HISTORIC AND DESIGN REVIEW COMMISSION

June 21, 2017

HDRC CASE NO: 2017-281
ADDRESS: 369 CLUB DR
LEGAL DESCRIPTION: NCB 6704 BLK 14 LOT 18
ZONING: R-6 H
CITY COUNCIL DIST.: 7
DISTRICT: Monticello Park Historic District
APPLICANT: Albert Davila, Jr.
OWNER: Albert Davila, Jr.
TYPE OF WORK: Installation of freestanding front yard trellis
REQUEST:

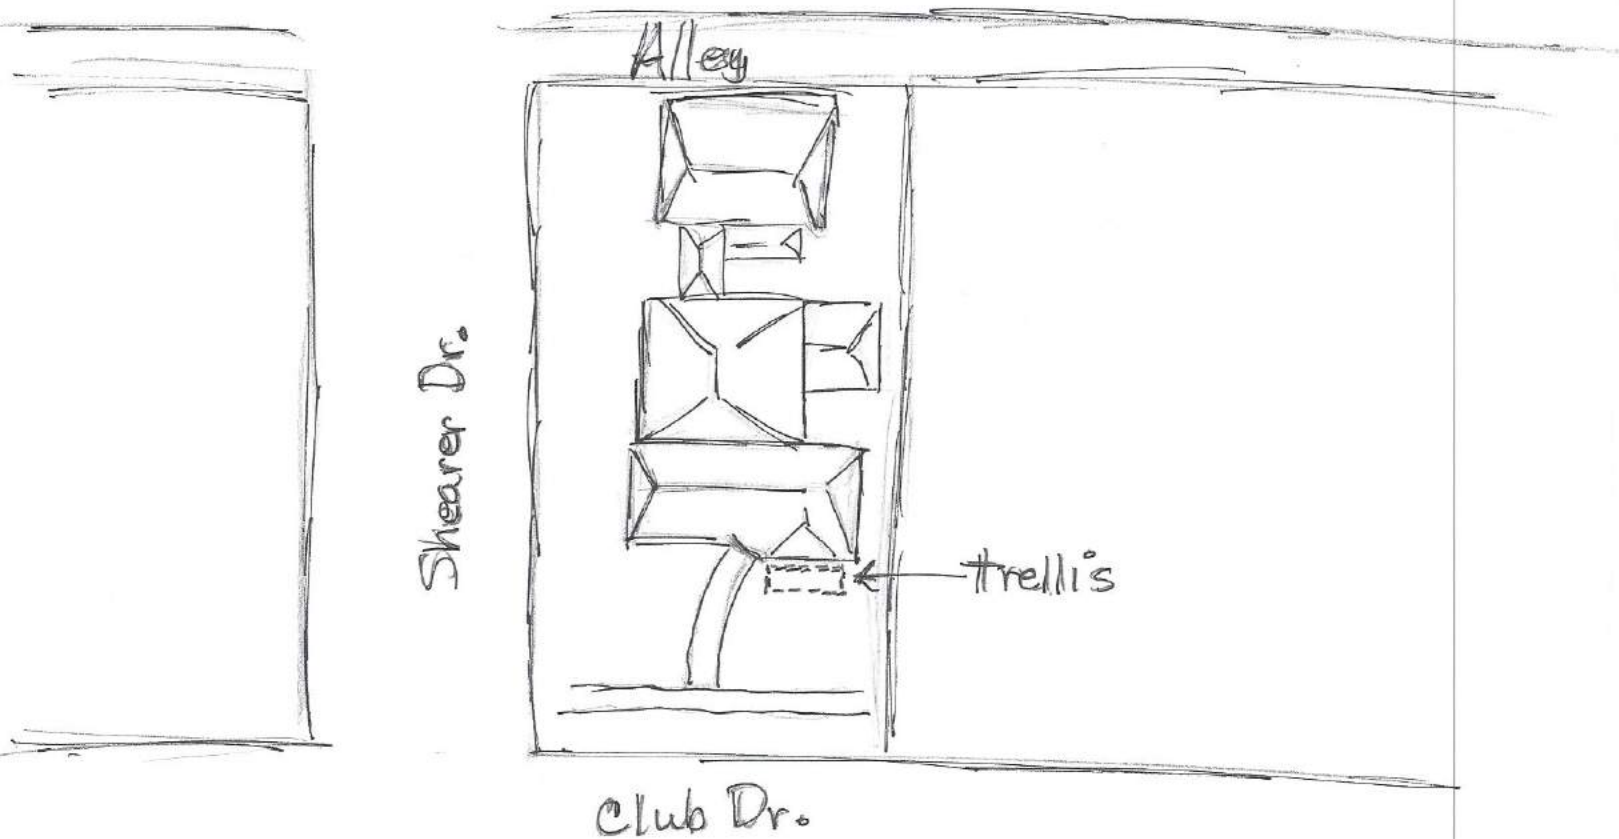
- a. The primary structure located at 369 Club Dr is a 1-story single family home constructed in approximately 1940 in the Spanish Eclectic style. The home is a contributing structure in the Monticello Park Historic District. The applicant is requesting approval to construct a freestanding wooden front trellis structure to support existing trumpet vines.
- b. According to Guideline 7.A.i, new porch elements should not be added where not historically present. While the trellis is freestanding and not structurally affixed, it obscures the primary structure's historic elements, including stone façade and front window. Additionally, wood trellises are not historically common in front yards in Monticello Park Historic District, and are not historically characteristic of stone structures of this particular

building style. The placement, design, and materiality are not appropriate for the structure and staff does not find the proposal consistent with the Guidelines.

Staff does not recommend approval based on findings a through b.
